UNITED STATES PATENT AND TRADEMARK OFFICE

APPLICATION NO.	FILING DATE	FIRST NAMED INVENTOR	ATTORNEY DOCKET NO.	CONFIRMATION NO.
10/583,238	06/16/2006	Albrecht Hofmann	3477	8264

Office Action Summary	Application No.	Applicant(s)	
	10/583,238	HOFMANN ET AL.	
	Examiner	Art Unit	
	LISA KLAUS	2833

DETAILED ACTION

(US 3,952,239), figure 1.

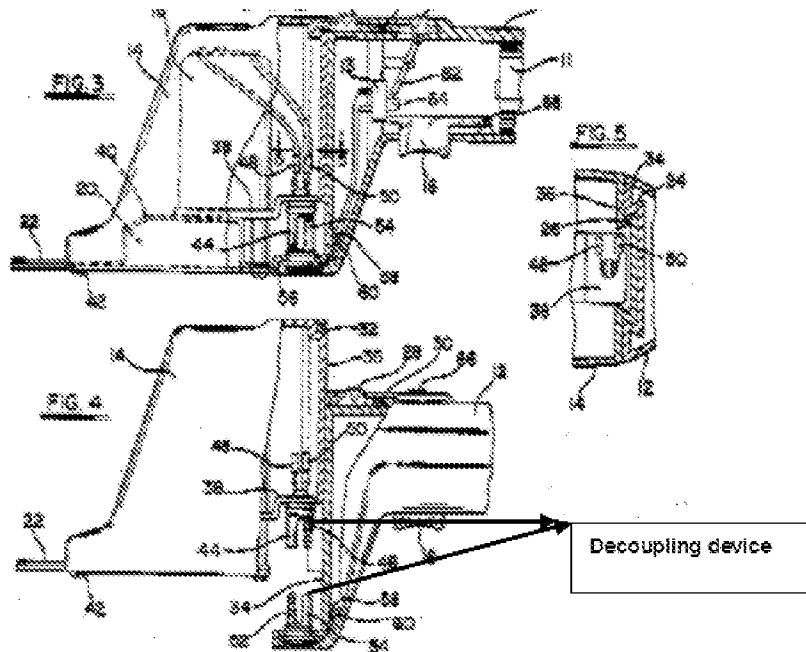
Claim 1 is rejected under 35 U.S.C. 102(b) as being anticipated by Owings et al.

Owings discloses a modular cordless tool comprising:

- a power supply unit 11 that can be removed on the device side for supplying electrical power, with at least one indirectly actuatable switch for switching a drive machine on and off, wherein a decoupling device (see figure below) decouple the switch 64 and a switching means 16 that actuates the switch 64 (from the rest of the unit 14).
